April 10, 2001
NUH61B-TNW0104-01

Subject: TN West Review Comments of the Preliminary Certificate of Compliance and Safety Evaluation Report for Standardized NUHOMS® System 61BT DSC Amendment

Comments on the Preliminary NUHOMS® CoC (61BT DSC Amendment)

Figure K.1-1
NUHOMS® -61BT DSC Components

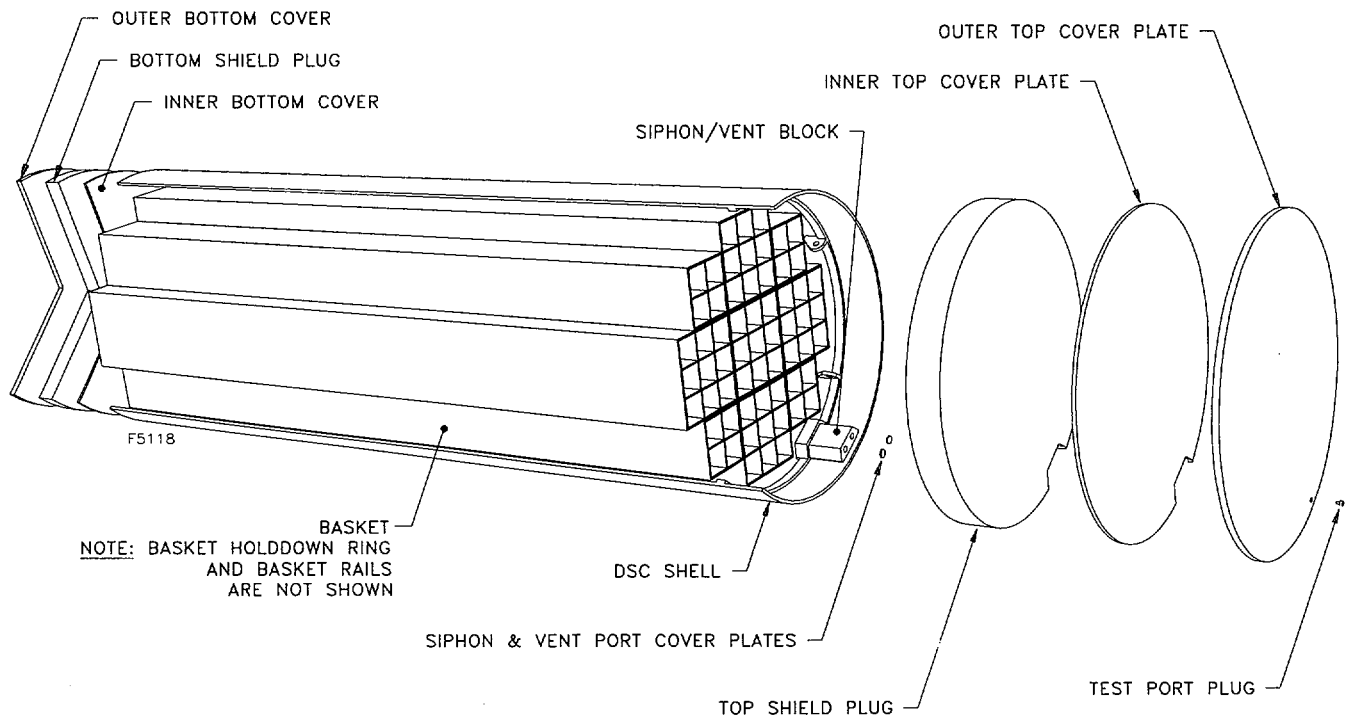
1. Revise Figure 1 to change the term “Vent Port Plug” to “*Test Port Plug*” to be consistent with the drawings included in Chapter K.1.5 of the SAR. A revised version of SAR Figure K.1-1 showing the correct description is included with this submittal.
2. Page 1-1, para 1.1: Revise second sentence to say “*Boral*®, borated aluminum or boron carbide/aluminum metal matrix composite plates provide criticality control ..”
